To
The Environmental Engineer
Regional Office
A.P. Pollution Control Board
Visakhapatnam.

Sub:	M/s. Maridi Eco Industries (Andhra) Private Limited, Sy. No. 314, Kapulauppada (V), Bheemunipatnam (M), Visakhapatnam - Reply to the Show cause notice - reg
Ref:	SC Notice No.1252/PCB/RO-VSP/TF/2023 dt 24.01.2023

2. ASH Pit (s no V).

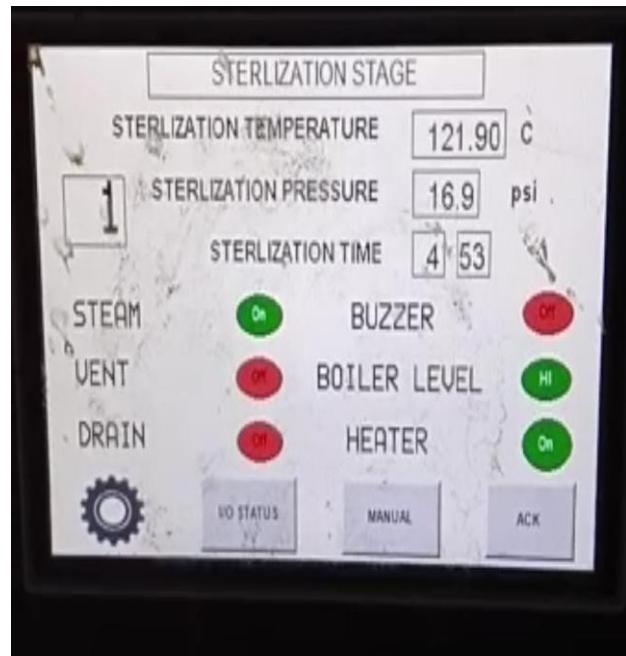
4	Vehicles transporting BMW are not provided with separate compartments to facilitate loading of BMW as per colour code. The facility is collecting mixed waste without following colour coding.	<p>Sir as explained above due to unsegregated waste by hospitals we could not comply 100 % colour coding. Regarding compartments we submit that colour coded bags themselves distinguish the waste. We submit that hence forth we will bring to the notice of APPCB about the HCFs not following the segregation.</p>
5	A shed is to be constructed over ash collection pit to avoid rain water mixing. Spillages around ash collection pit shall be avoided.	<p>sir the ash pit is covered with RCC slab. During emptying with JCB it would be difficult if shed is provided. However to avoid rain water mixing we have provided roof as submitted in photograph.</p>
6	A very less quantity of needle/sharp storage is observed in the pit	<p>We will bring to the notice of the APPCB regarding the HCEs not submitting PP containers</p>
